Driveline Vibration Under Deceleration Around 10 - 30 MPH

Service Category Drivetrain

Section Drive Shaft/Propeller Shaft

September 1, 2017 Rev1:

Figure 2.

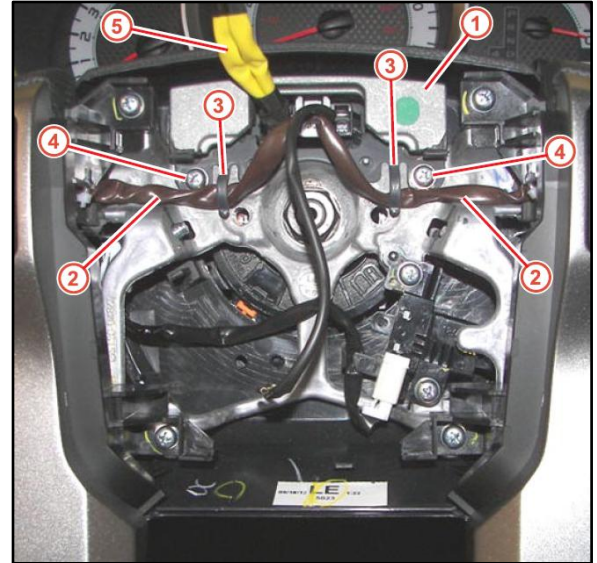
4. Install the steering wheel damper with two NEW screws in the locations shown.
Torque: 2.35 N*m (24 kgf*cm, 20.8 in*lb)

NOTE
Secure the steering wheel switch wires to the steering wheel damper bracket hooks as shown.

Figure 15.

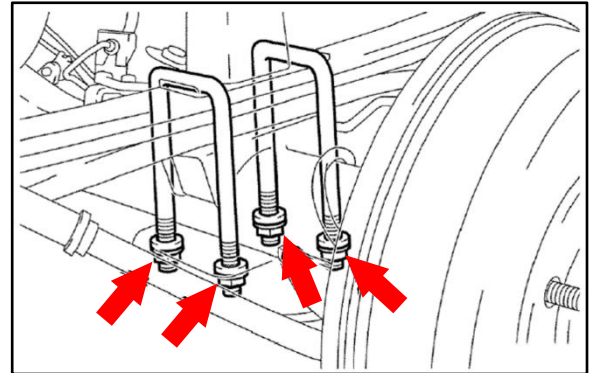
15. Replace the leaf spring using the part information in the following table:

When tightening the U-bolt nuts, be sure to set to the following torque:
 Torque: 60 N*m (610 kgf*cm, 44 ft*lbf)

Fasteners for shocks and leaf spring bushings should be tightened. Then, torque for these joints should be set while the vehicle is on the ground.
